AS-BUILT PLANS

WATER DISTRIBUTION SYSTEM

TGC Addition

2025-008225PPW

LINE 1

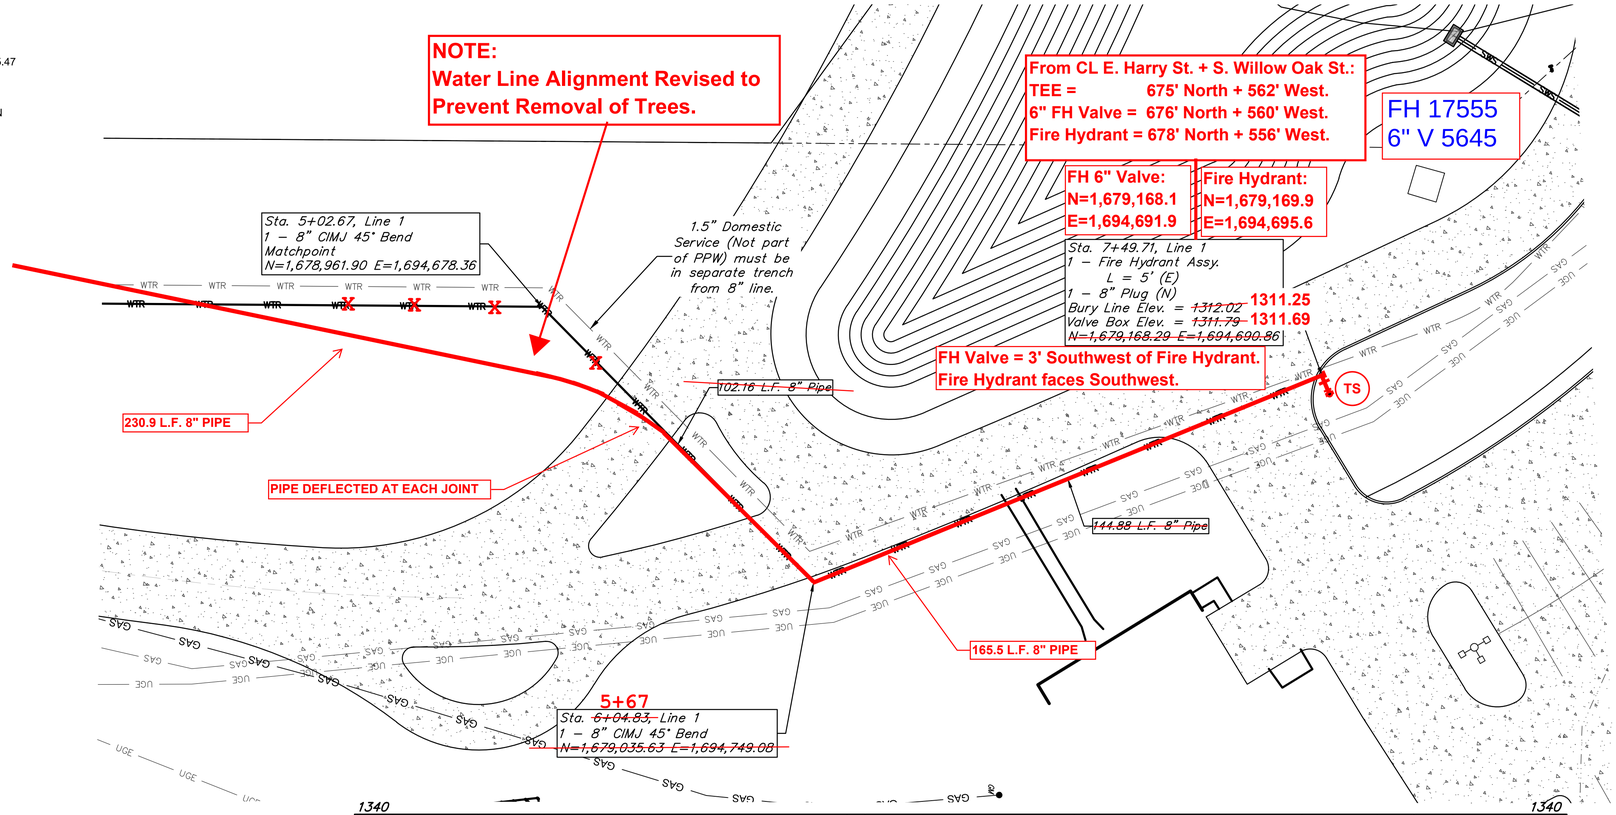
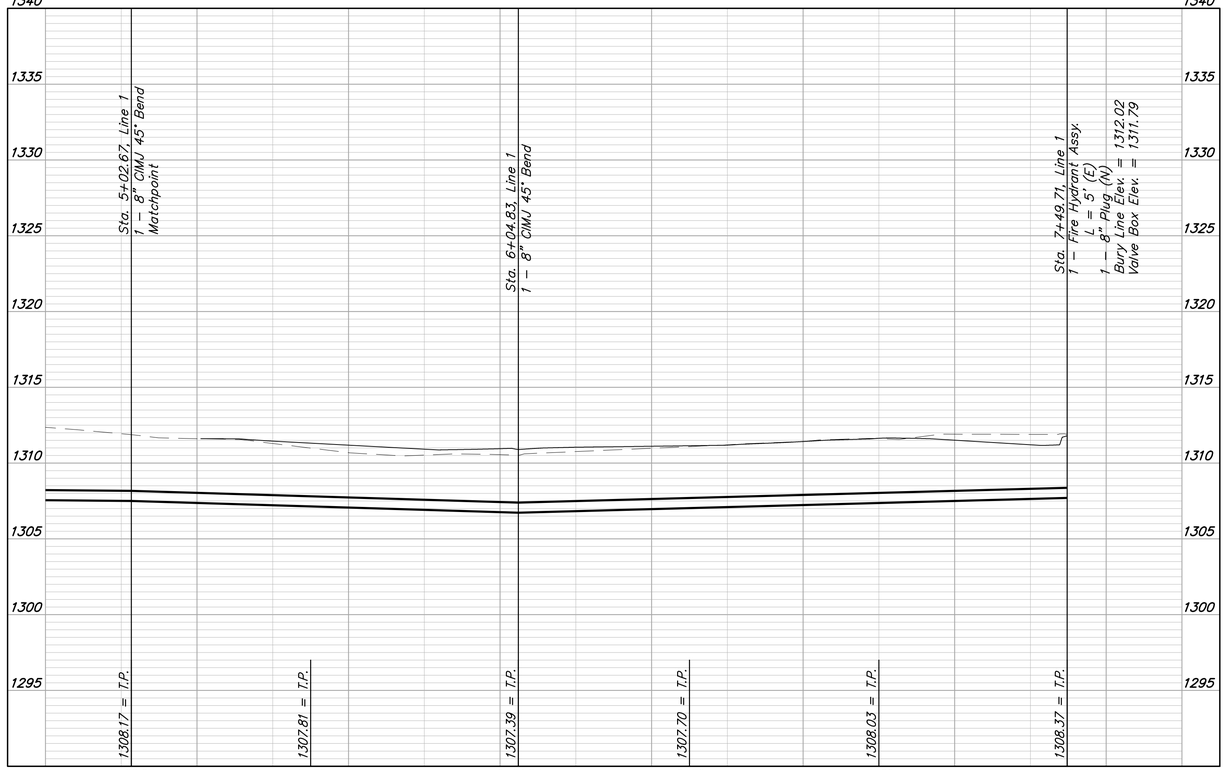
NOTE:
Water Line Alignment Revised to Prevent Removal of Trees.

Sta. ~~1+06.50~~, Line 1
Construct 8" Fire Service Vault with double detector check assembly per Wichita Specifications per Standard Vault Detail Sheet and City Standards.
~~N=1,678,565.82 E=1,694,686.61~~

1+09.5

Top Lid = 1312.61
N=1,678,571.3 E=1,694,686.9
